## Docket No. 217 - Development and Management Plan Inspection

Northeast Utilities Service Company Certificate of Environmental Compatibility and Public Need for the construction of a 345-kV electric transmission line and reconstruction of an existing 115-kV electric transmission line between Connecticut Light and Power Company's Plumtree Substation in Bethel, through the towns of Redding, Weston, and Wilton, and to the Norwalk Substation in Norwalk, Connecticut.

**Date:** October 25, 2006

**Inspector:** Diana Walden, BSC Group

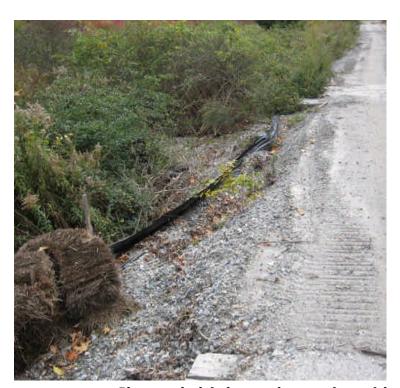
(345kV H-Frame): Photo on the left shows the area at pole #25 where mats and disturbed soil are now present on the previously restored area. Silt fence should now remain in place due to the additional disturbance. (Norwalk Section): Photo on the right shows mats remaining at the wetland crossings at Kent Rd south. 10/25/06.
